Metro Inner Development Assessment Panel Agenda

- 3.1 Lot 2 (No. 454) Murray Street, Perth - Proposed 7 level mixed-use development containing 68 tourist and visitor accommodation units and a ground floor café – DAP/26/03083

RESPONSIBLE AUTHORITY REPORT – FORM 1	
DAP Name:	Metro Inner DAP
DAP File No:	DAP/26/03083
LG Reference:	DAP-2026/5068
Proposed Development:	Proposed 7 level mixed-use development containing 68 tourist and visitor accommodation units and a ground floor cafe
Value of Development:	\$10 million
Owner:	Rich Peace Pty Ltd
Applicant:	Urbanista Town Planning
Local Government Area:	City of Perth
Responsible Authority:	City of Perth
Authorising Officer:	Julia Kingsbury, General Manager Planning and Sustainability
Application Acceptance Date:	25 March 2026

RESPONSE TO REQUEST FOR FURTHER INFORMATION

1
dA1.08
north elevation
1 : 100

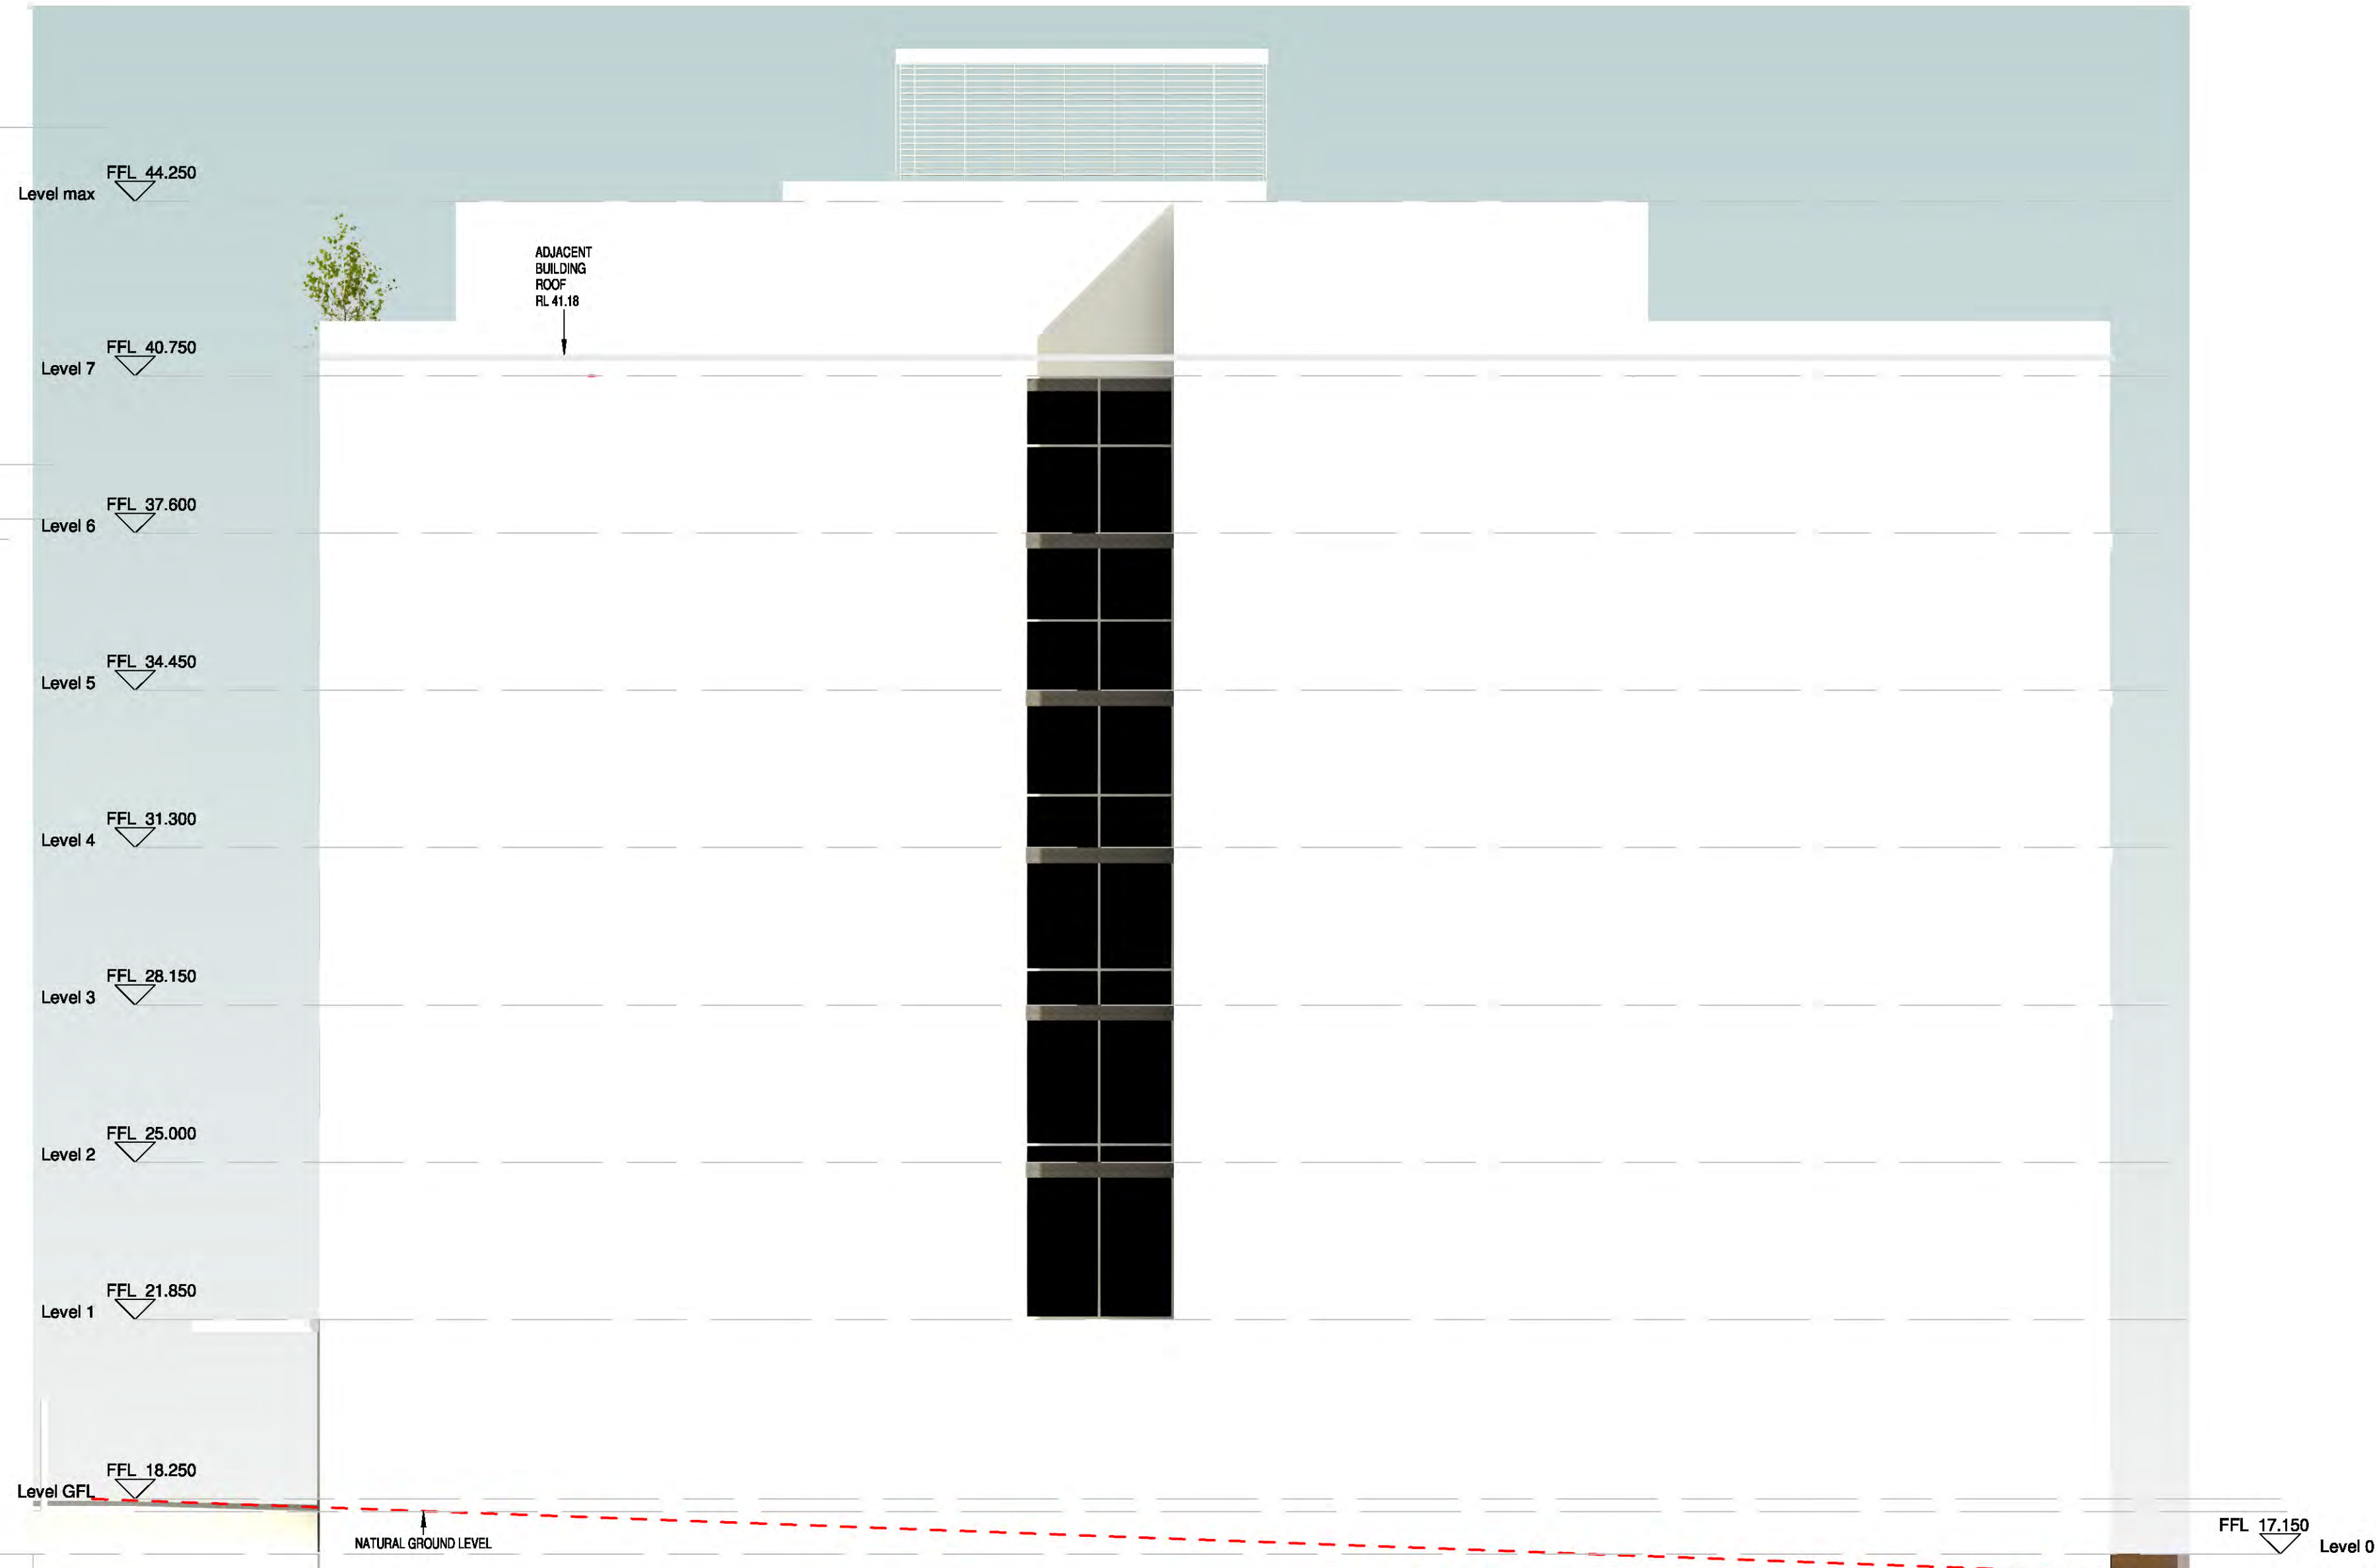
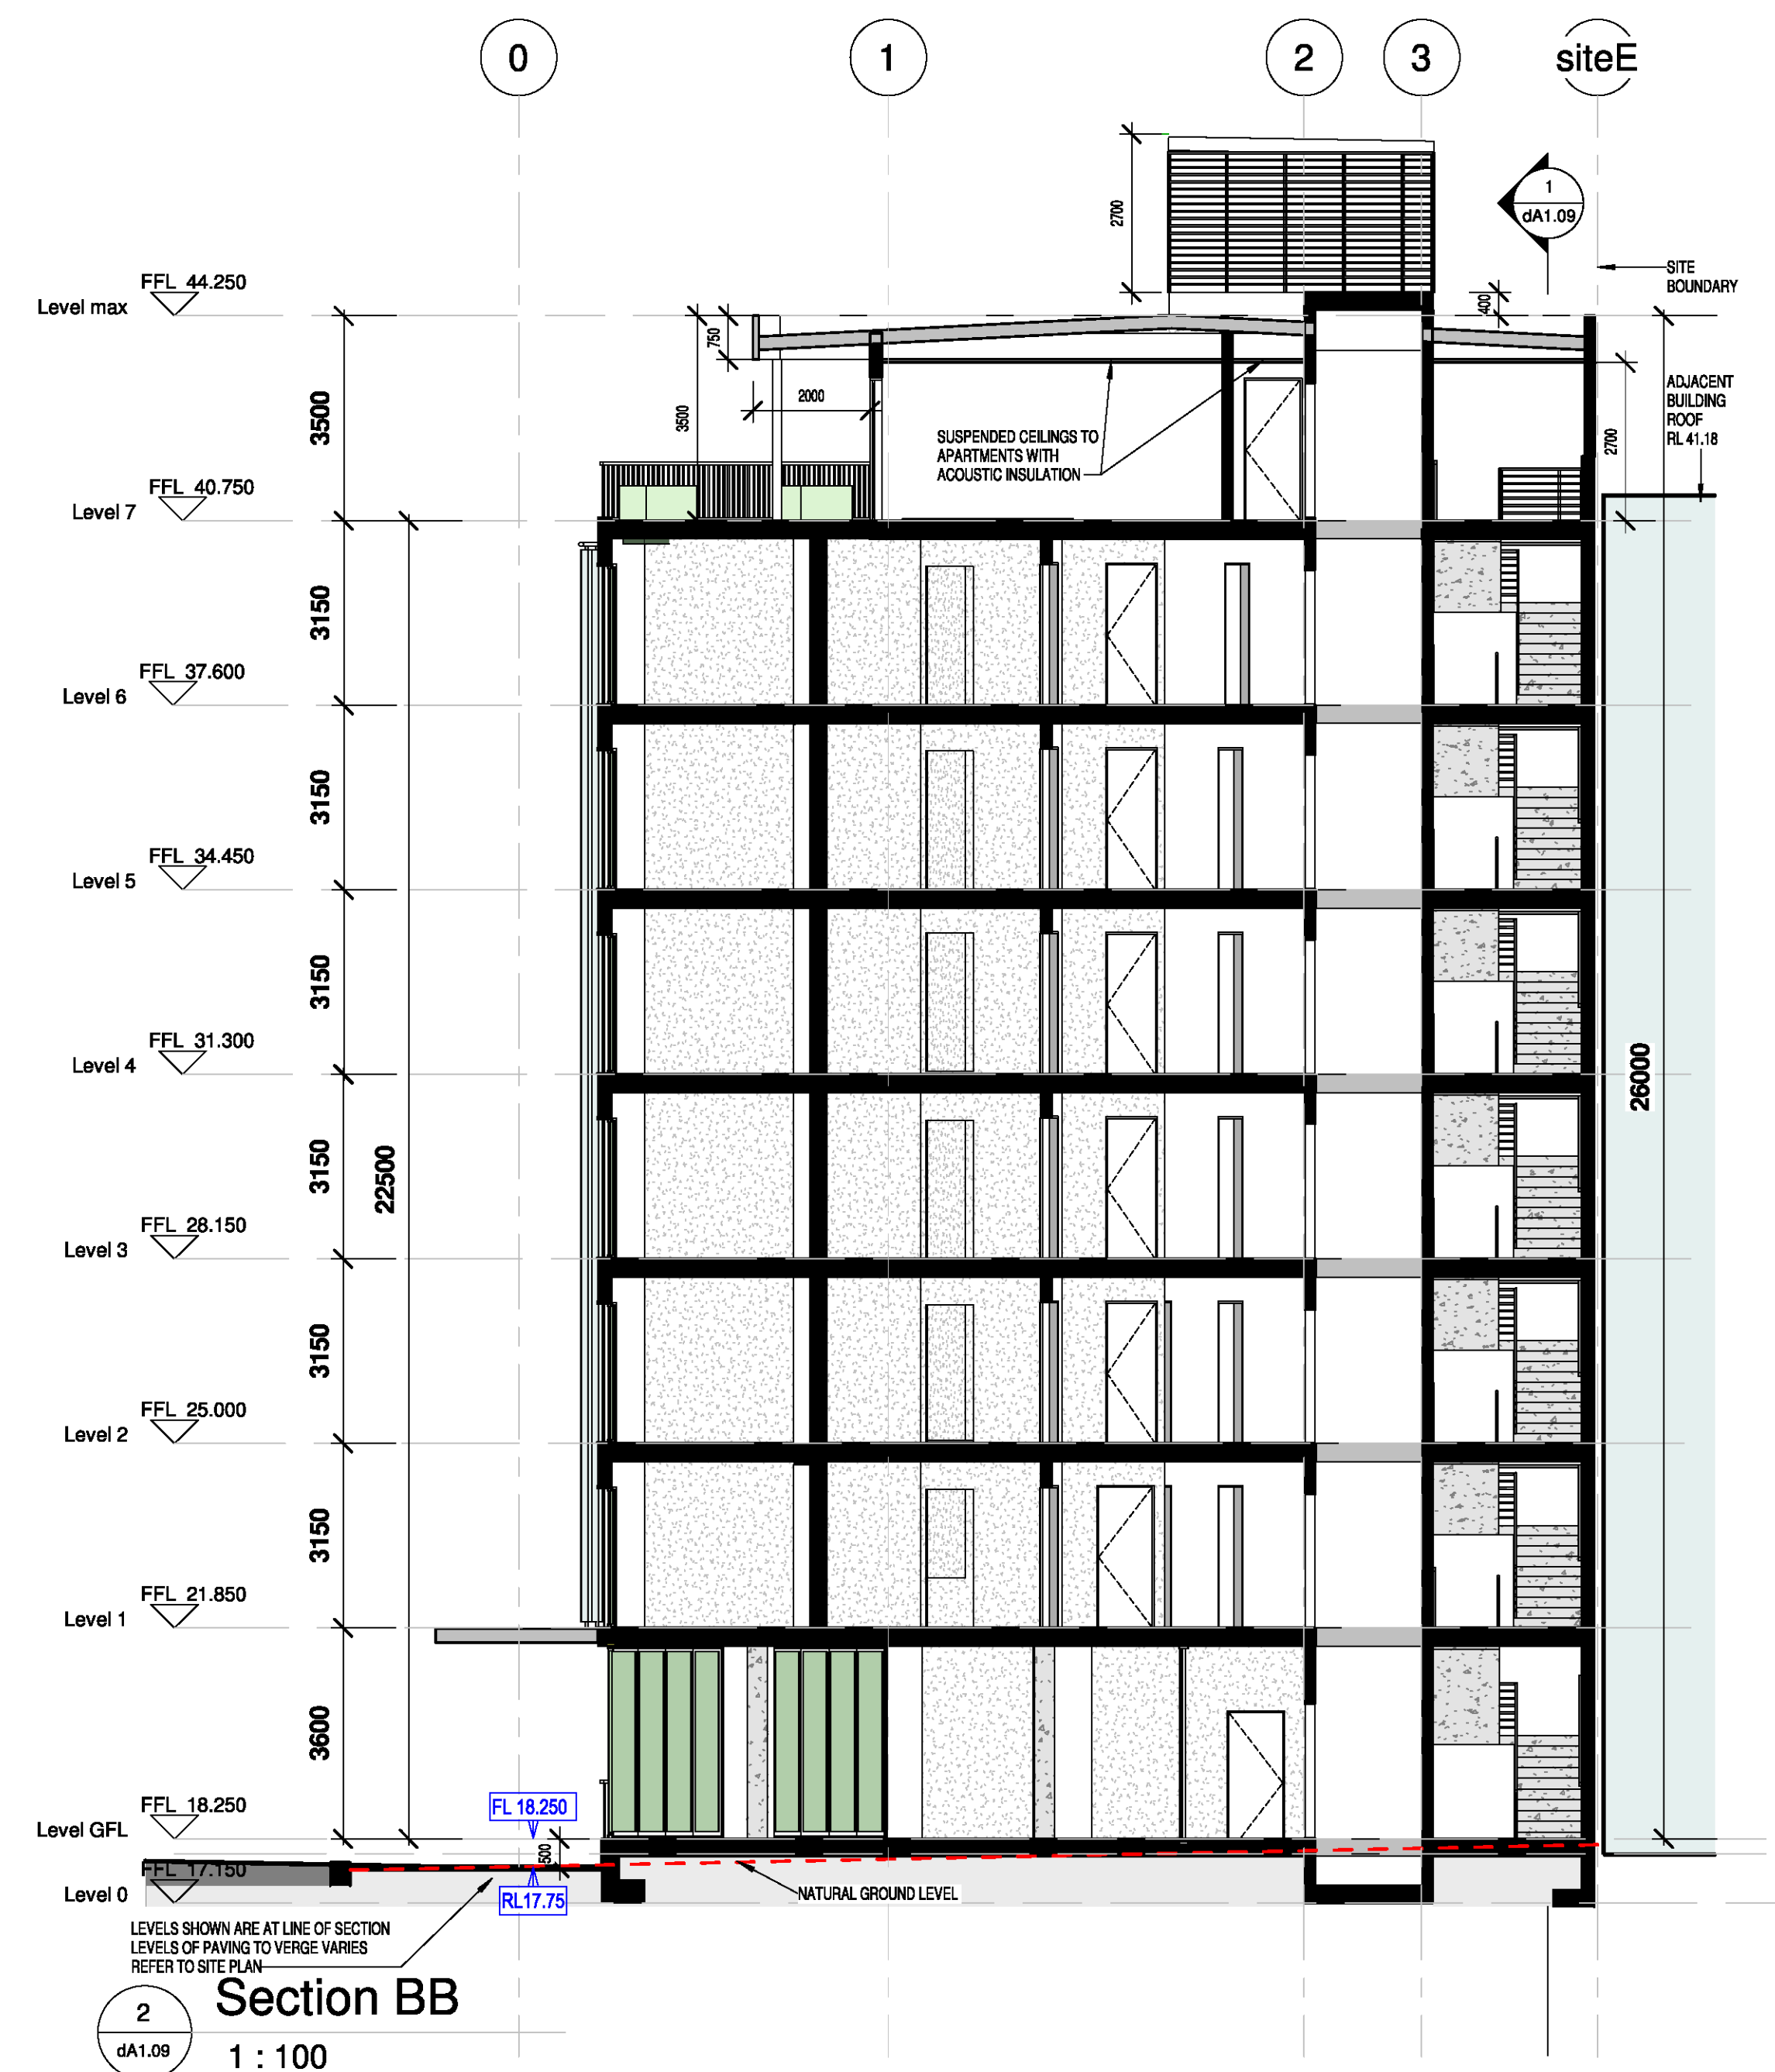
City's Comments	Applicant Response
• Ensure the screen on the Milligan St elevation and any other architectural features attached to the building do not encroach more than 250mm into the public realm. • Review the northern elevation – it adjoins a lot boundary, but the building (a balcony) appears to be built up to the property boundary. Consider whether it could possibly be built up against. • Consider providing justification for elements of the proposal that do not meet the relevant CPS2 development requirements – maximum building height, setbacks of upper building levels, rear (north) setbacks and bicycle parking.	• The plans have been amended showing no architectural features encroaching more than 250mm. • Additional planning justification for building height, setbacks and bicycle parking is provided below. • It is noted that the City previously requested justification for plot ratio, however this was assessed to be compliant.

- Canopy should be dashed on floor plan.
- Location of A/C condensers illustrated on plans.
- Show natural ground level (NGL) dashed on elevation plans.
- Show outline of neighbouring buildings dashed on elevation plans.
- Show suspended ceilings in wet areas.
- Show full extent of overshadowing as it appears cut off.
- Show overshadowing at 10am, noon and 2pm on the 22nd of August, 22nd September and 22nd October as per the Major DA kit.
- Ensure the 3D imagery and elevation plans are consistent (i.e. window arrangements, architectural features and services).
- Show all existing street trees, furniture, light poles etc on the plans.

- The canopy is shown dashed on the floor plan.
- A/C condensers shown on the roof plan.
- The NGL is shown on the elevation plans.
- Neighbouring buildings are shown dashed and also in the updated perspectives.
- Suspended ceiling shown in wet areas.
- Full extent of overshadowing shown, along with the times of day requested.
- 3D perspectives are consistent.
- Street trees, furniture and light poles are shown on the plans.
